## Wheaton Woods Elementary School Modernization, Mandatory Referral No. MR2016001

Completed: 09/04/15

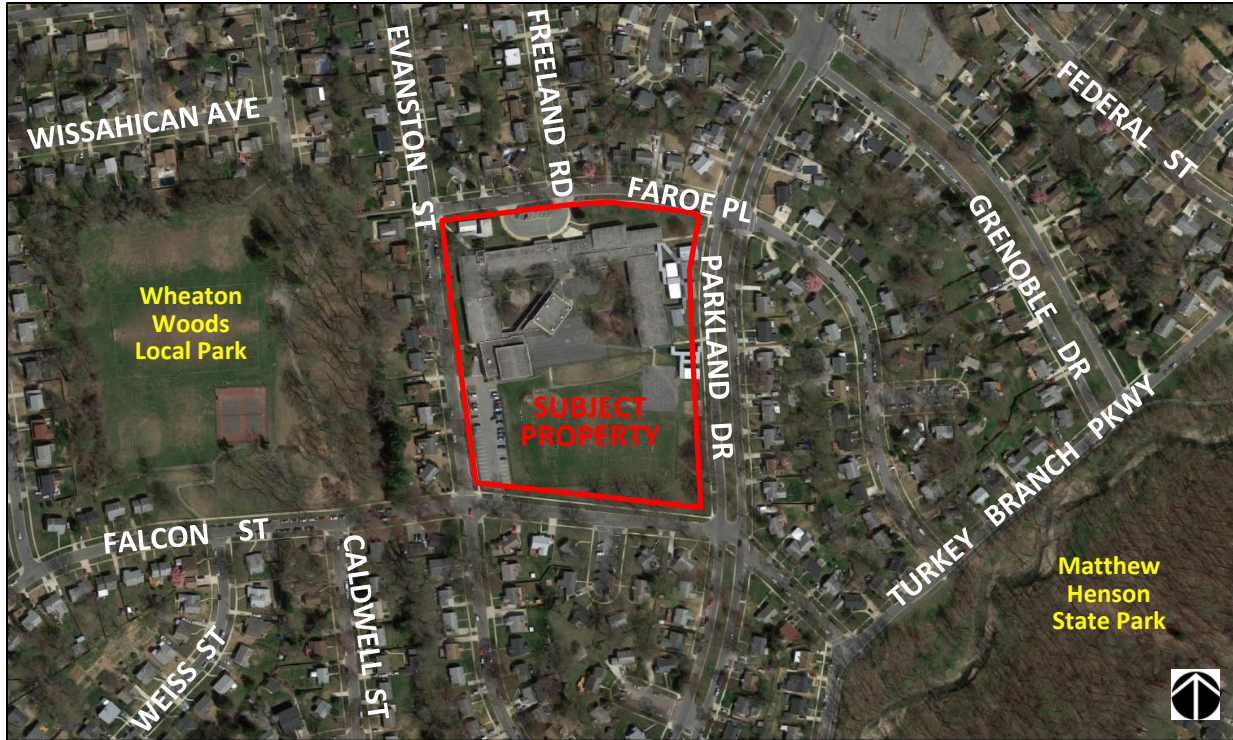
2. The Applicant should upgrade all sidewalks at the perimeter of the school to be a minimum of five feet wide per the Road Code standards.
3. The Applicant should construct a pedestrian path from the sidewalk along Evanston Street to access the playing fields and basement entry/exit.

4. The Applicant should mark a pedestrian crosswalk at the curb cut along Falcon Street consistent with the other proposed crossings.
5. The Applicant should provide inverted-U (or equivalent) bike racks near the building entrances to serve users of playing fields.

6. The Applicant should consider including a vegetable garden, blooming perennials, or small trees in the courtyard design, where feasible.

1. A pedestrian path from the sidewalk along Evanston Street to access the playing fields and basement entry/exit.
2. Upgrading the existing sidewalks along the entire perimeter to at least 5 feet in width.
3. A marked pedestrian crosswalk at the existing curb cut at Falcon Street consistent with the other proposed crossings.
4. Inverted-U bike racks (or equivalent) at the main building entrances and appropriate location(s) to serve the non-school users of playing fields.
